Addendum No. 01

Subject: **Potter Thomas Classroom Modernization Project
B-021C, B-022C, B-023C of 2018/19**

Location: **Potter Thomas Elementary School
3001N. 6th Street
Philadelphia, PA 19133**

This Addendum, ***dated February 26, 2019***, shall modify and become part of the Contract Documents for the work of this project. Any items not mentioned herein, or affected by, shall be performed strictly in accordance with the original documents.

4 226 NEW WORK
SCALE: 1/4" = 1'-0"

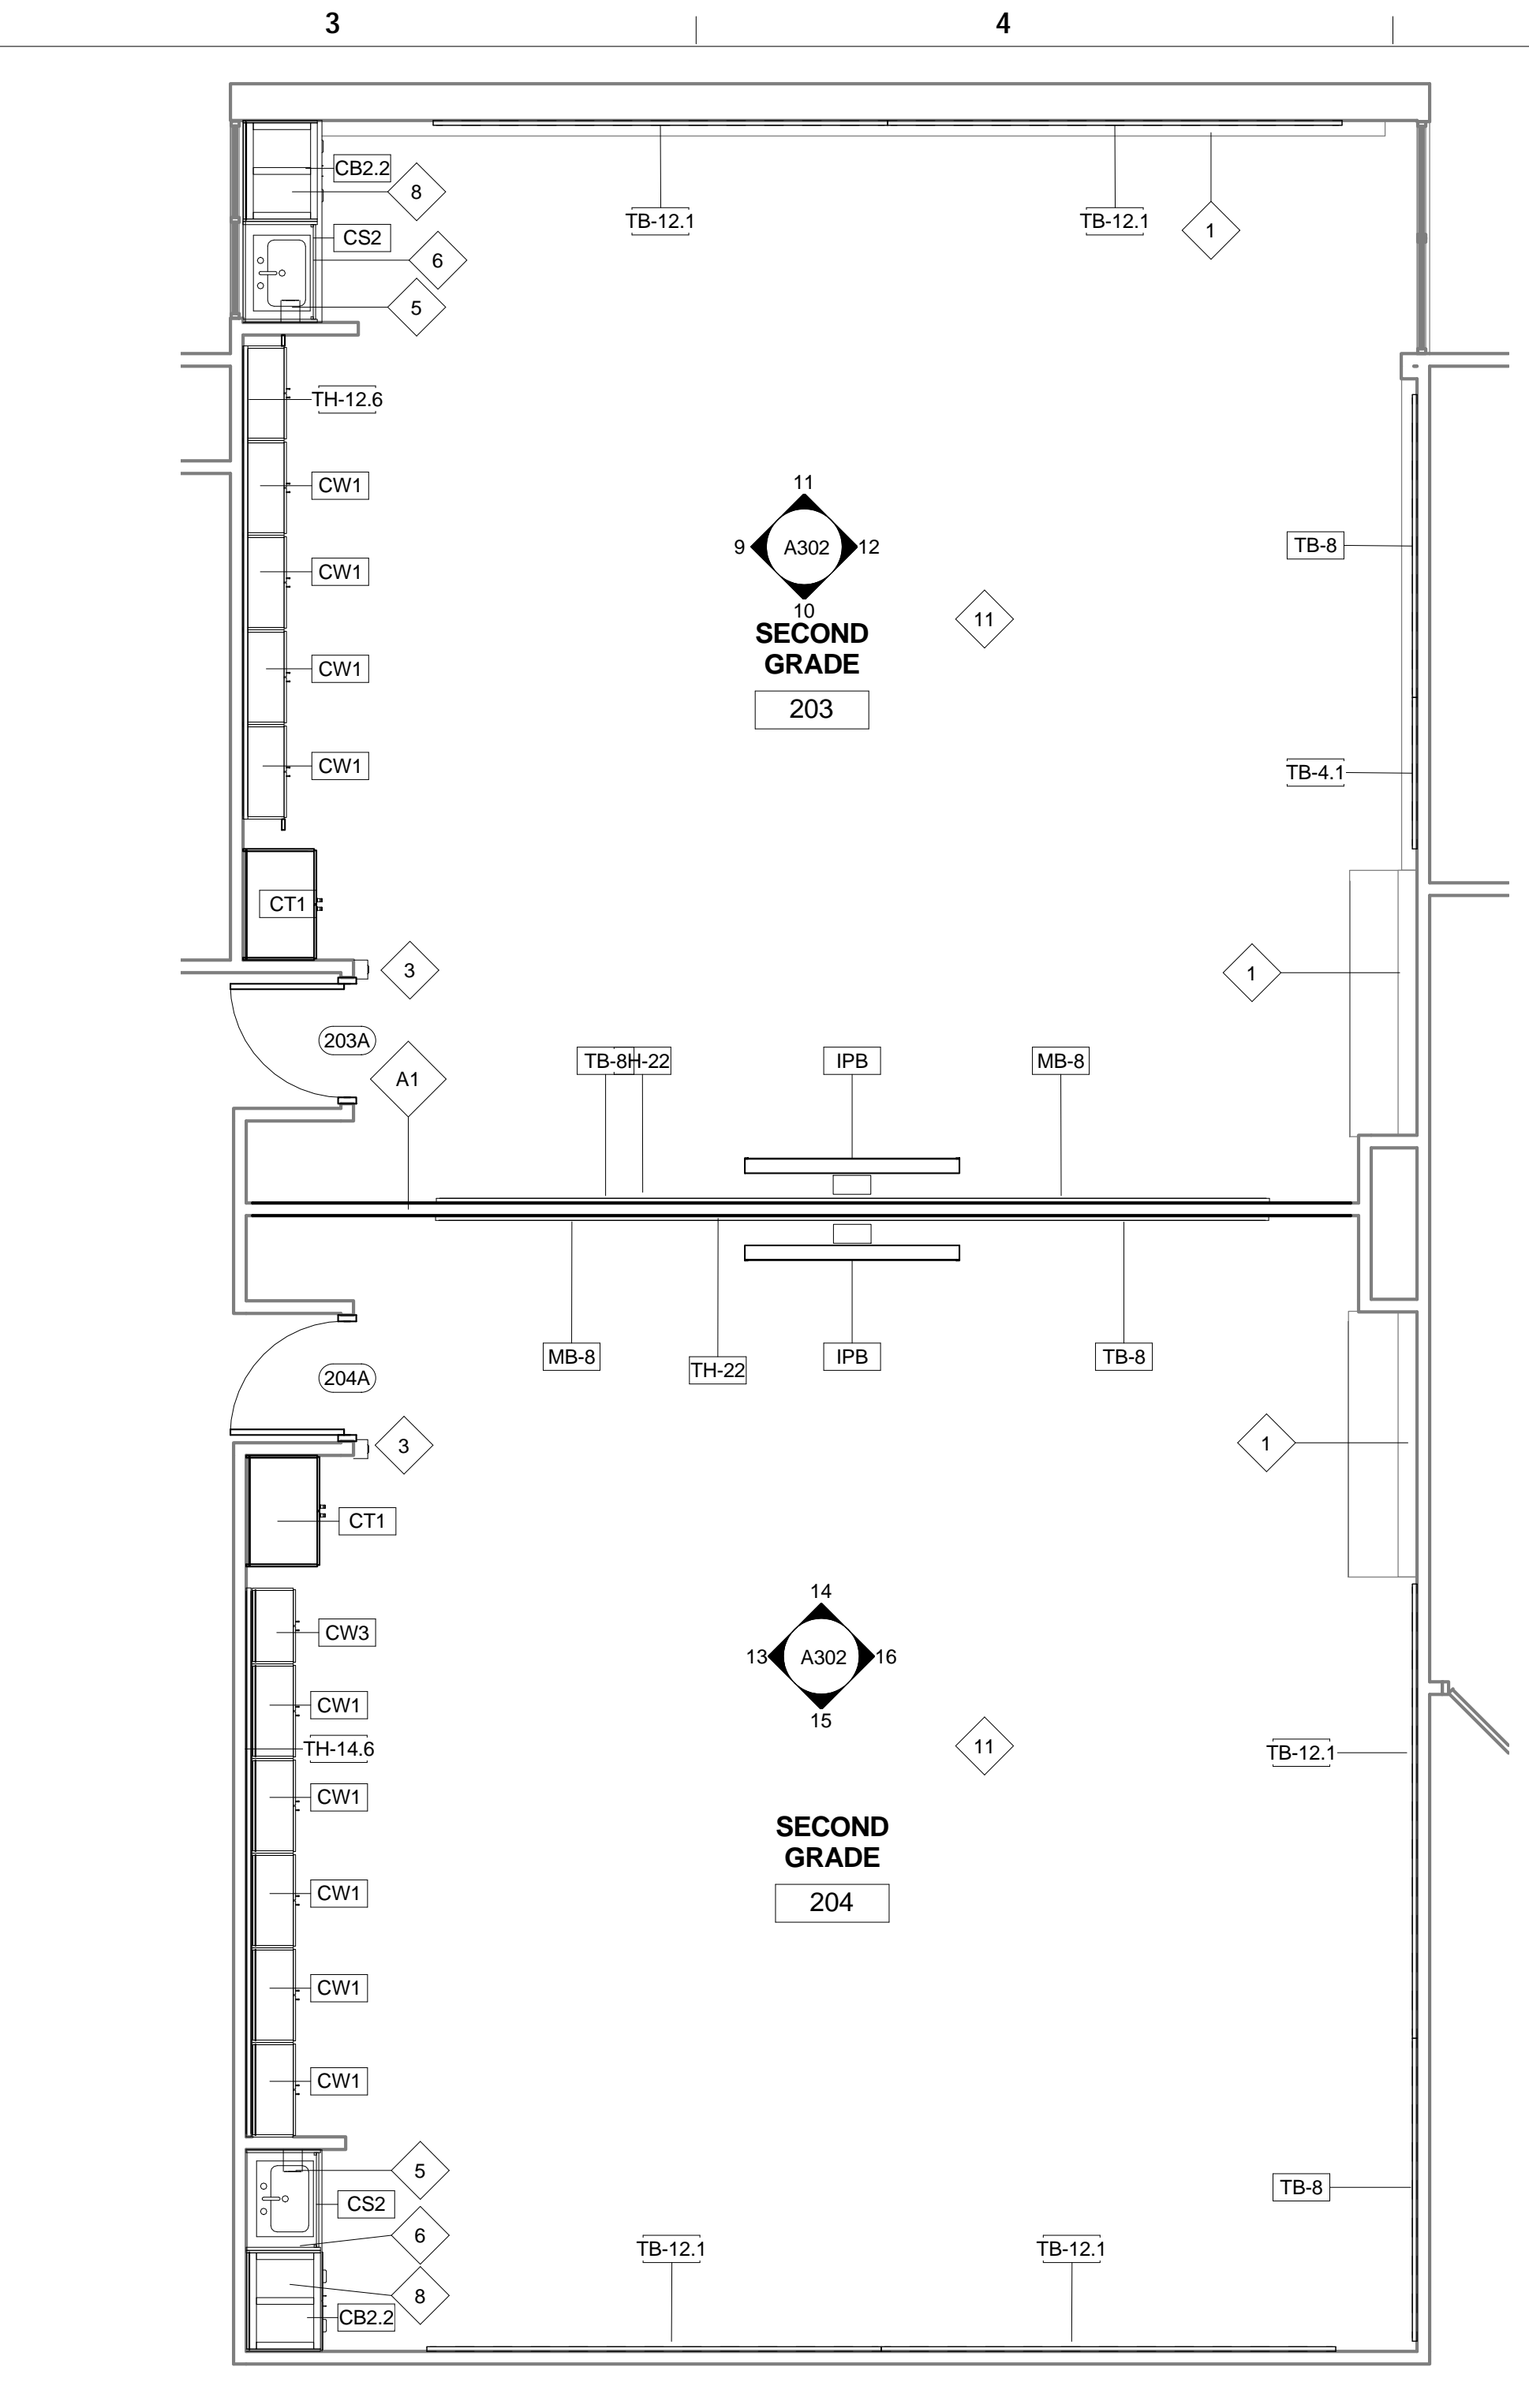
- a. A101: 201,202,203,204,205,206 & 226 NEW WORK:

DETAIL 4 IS REVISED, SEE A101 REV 1 ISSUED WITH THIS ADDENDUM.

6 WALL CABINET & WALL HOOK DETAIL ENLARGED SCALE: 3" = 1'-0"

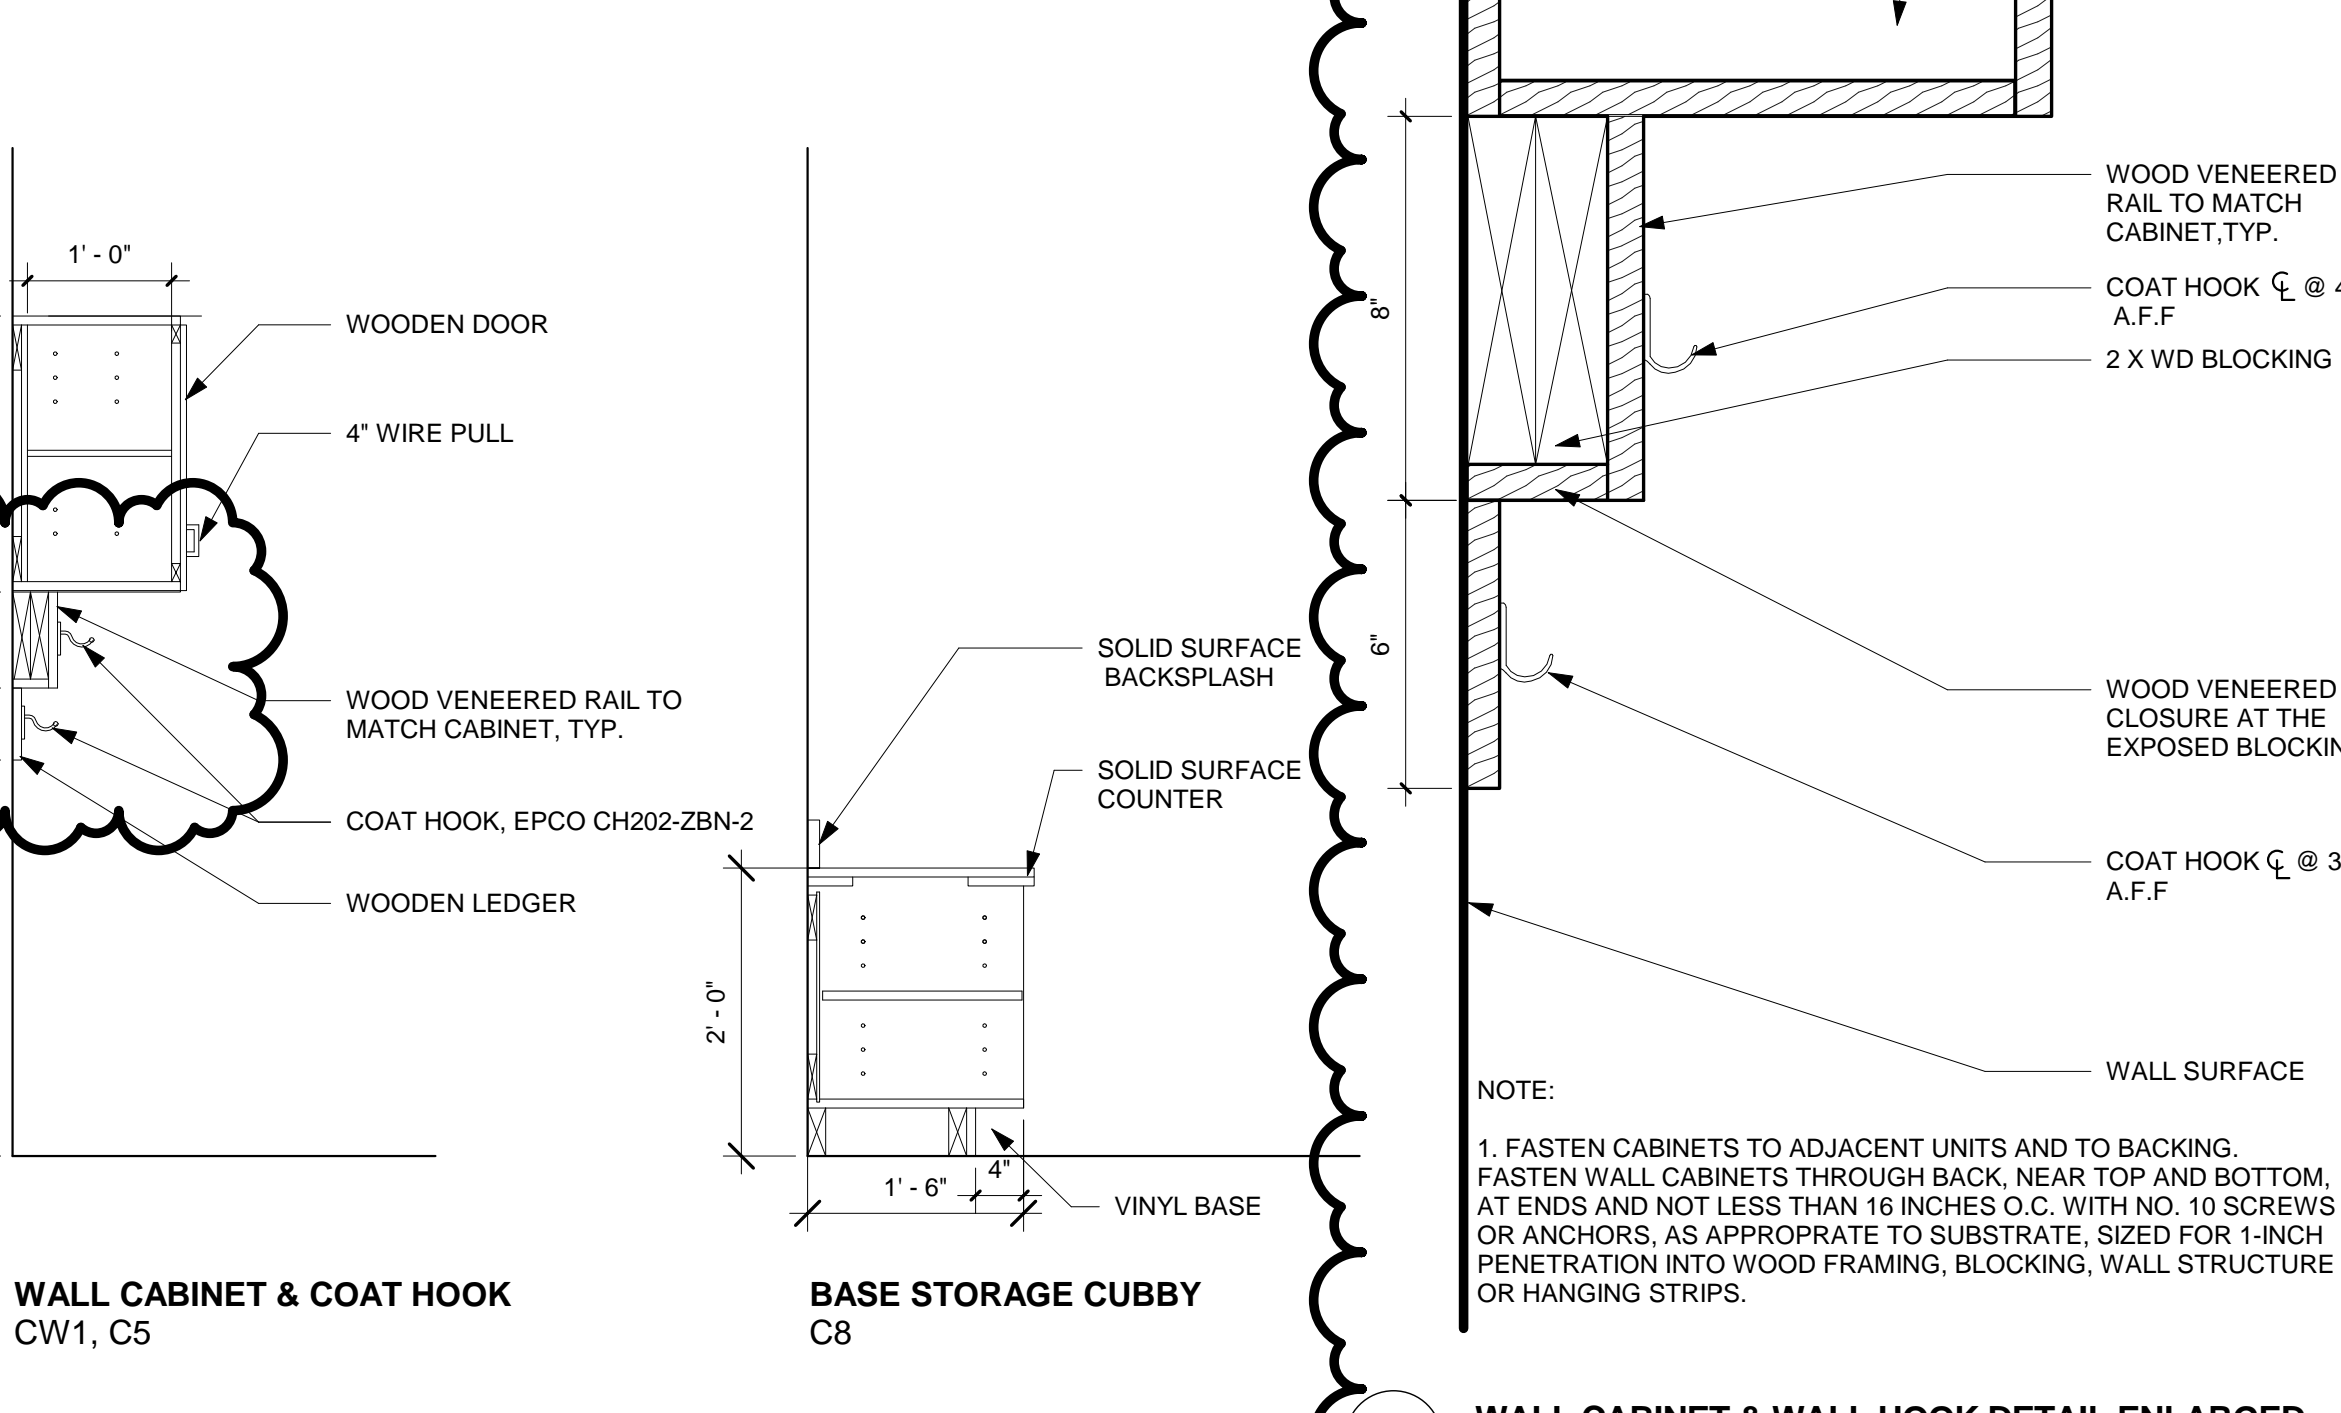
e. A300: CASEWORK DETAIL:

Delete "WALL CABINET & COAT HOOK" details

Add "WALL CABINET & WALL HOOK DETAIL" and "WALL CABINET & WALL HOOK DETAIL, ENLARGED"

THE ABOVE CHANGES TO THE CASEWORK DETAILS ARE SHOWN IN THE REVISED A300-Rev 1 DRAWING ISSUED WITH THIS ADDENDUM.

INTERIOR ELEVATIONS

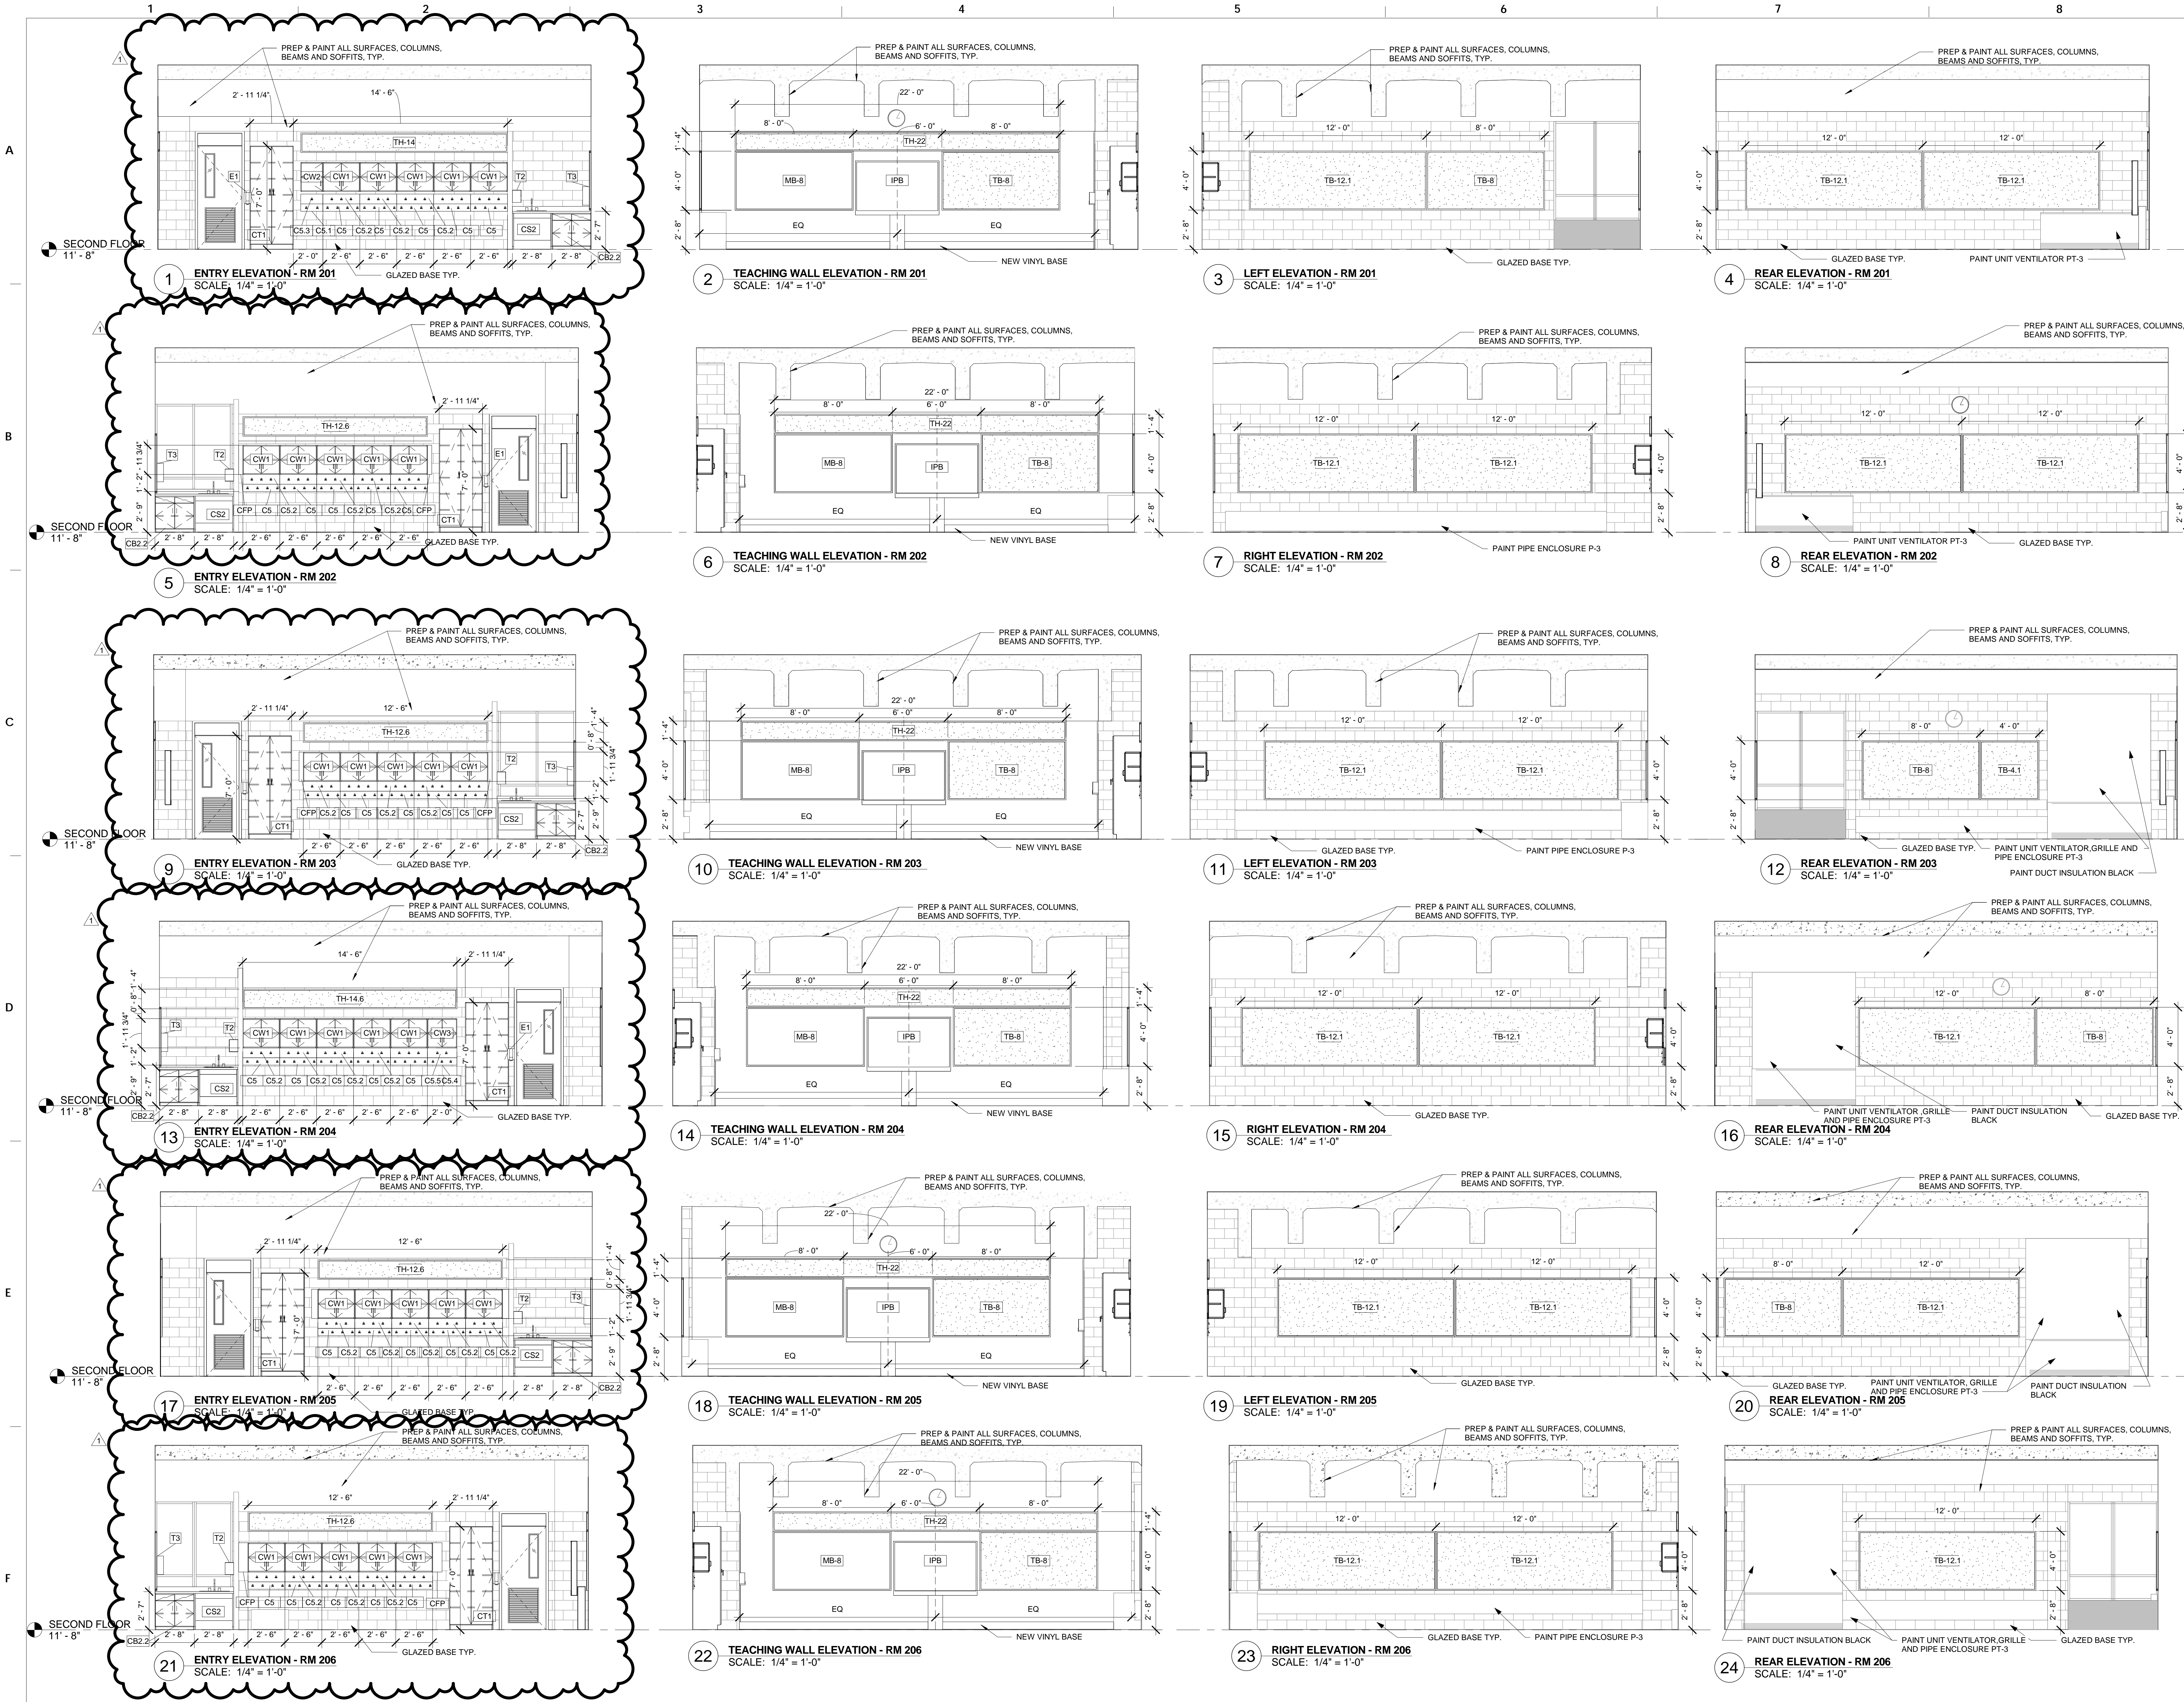
f. A302: INTERIOR ELEVATIONS

DETAILS 1, 5, 9, 13, 17, 21 ARE REVISED, SEE A302 REV 1 ISSUED WITH THIS ADDENDUM.
